RECALL 561 - 4.0L ENG. FED. VEHICLES - OXYGEN SENSOR

1988 Jeep Cherokee

EMISSIONS RECALL #561 - OXYGEN SENSOR

Model(s): 1987-90 (XJ) Jeep Cherokee, Wagoneer
1987-90 (MJ) Jeep Comanche
Bulletin No.: 561
Date: October, 1993

Fig. 1: Wire Connector & Oxygen Sensor - Location

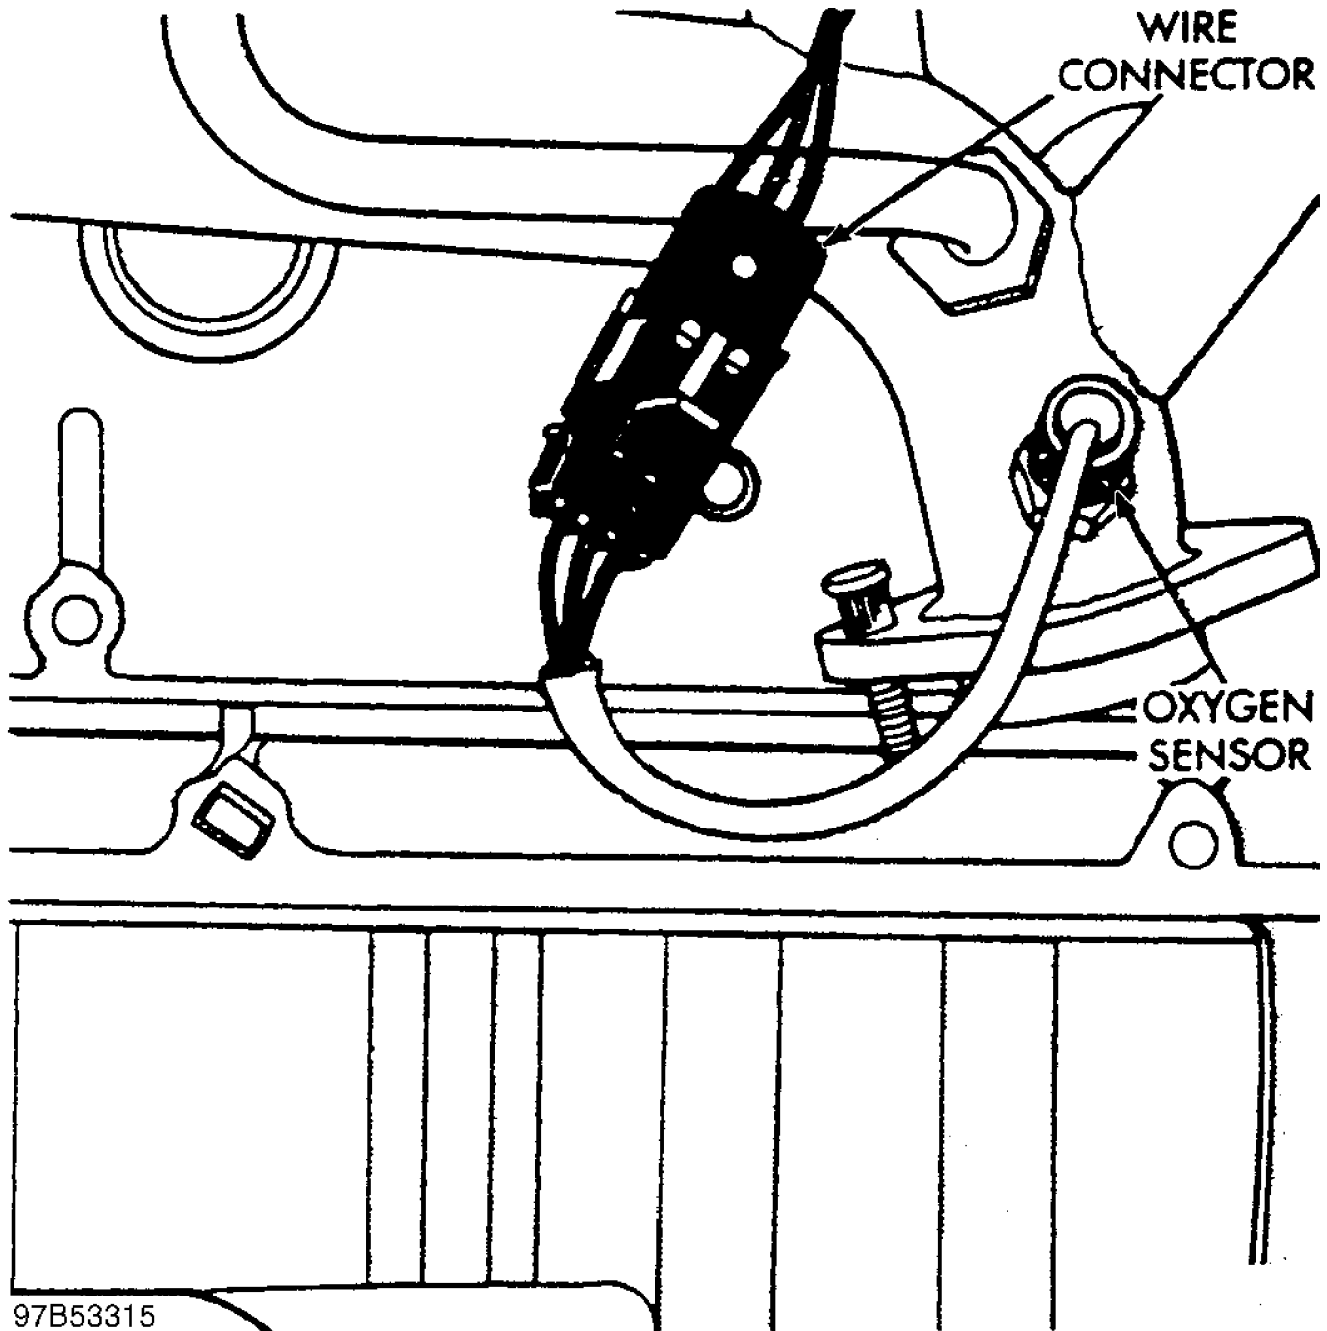
Failure of the oxygen sensor on the listed models, may cause a vehicle to be in violation of Federal Emissions Standards. To correct the condition, the oxygen sensor must be replaced with an improved design sensor.

1. Raise Vehicle on a hoist and locate oxygen sensor in exhaust manifold as shown in Fig. 1.
 - a. If the oxygen sensor has a metal stone shield around the sensor body continue with Step B.
 - b. If the sensor does not have a stone shield, a new sensor has already been installed and no further service is required.

1. Disconnect the oxygen sensor electrical connector.
2. Remove oxygen sensor using a crowfoot socket.
3. Clean exhaust manifold threads.

4. Install provided oxygen sensor (P/N C3905610). Tighten to 30 N.m (22 ft-lb).
5. Connect oxygen sensor connector.
6. Lower vehicle.
